# International Isotopes Inc.

Subject: Request to Amend NR-1235-S-102-S.

International Isotopes Inc. requests to amend Registry of Sealed Sources and Devices Safety Evaluation of Sealed Source Number NR-1235-S-102-S to include a source geometry that replicates that of a syringe. International Isotopes Inc. considers the syringe geometry as an improvement over the standard 30 ml vial source geometry which is commonly utilized by many nuclear medicine facilities to calibrate instruments used to comply with § 35.63 *Determination of dosage of unsealed byproduct material for medical use* of Title 10 of the Code of Federal Regulations. As with the current BM06 Model, International Isotopes Inc. is the contracted manufacturing for the source which is distributed under the Bench/mark by RadQual label. Both companies are committed to provide the nuclear medicine industry with a calibration source geometry that closely resembles the actual dosage geometry. The companies have contracted with the United States National Institute of Standards and Technology to develop a NIST traceable standard for the syringe geometry.

Source Label Example

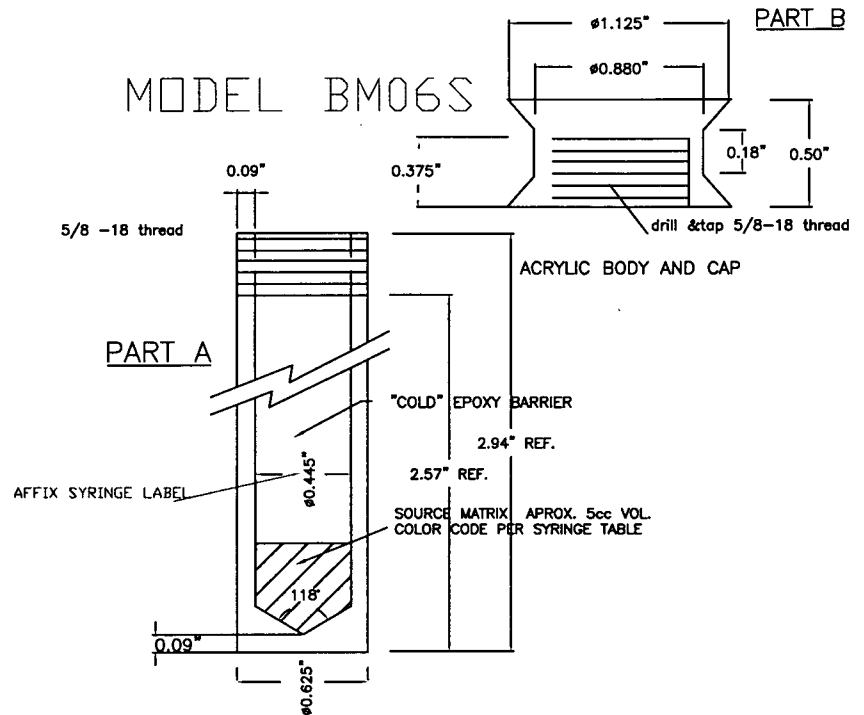
A new source label is provided for use in Attachment 1.

<b>CAUTION RADIOACTIVE MATERIAL</b>	BM06E(S)-##	Isotope-###	<i>Manufactured and distributed for RadQual, LLC, Aurora, OH, by International Isotopes Idaho, Inc., Idaho Falls, ID</i>
	0.00 mCi	000 MBq	
	Serial Number:	Lot #-Sequential #	
	Reference Date:	DD Mon. YY	
<b><i>Bench/mark</i></b> by RadQual
